PRODUCT BULLETIN # 20233

Issue Date: 13-Sep-2013

TITLE: Change SOD123-FL Package Maximum Height

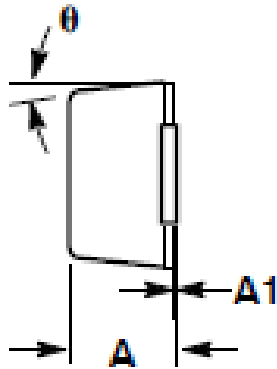
ON Semiconductor is notifying customers of its plan to change the maximum height of SOD-123FL package from 1mm to 0.98mm at SBN, Malaysia manufacturing site.

Comparison for Old and New Case Outline

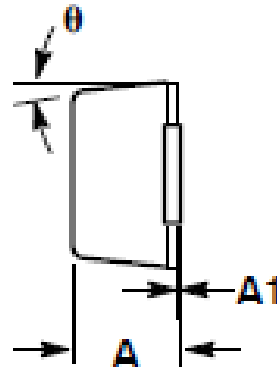
DIM	MILLIMETERS		
	MIN	NOM	MAX
A	0.90	0.95	0.98
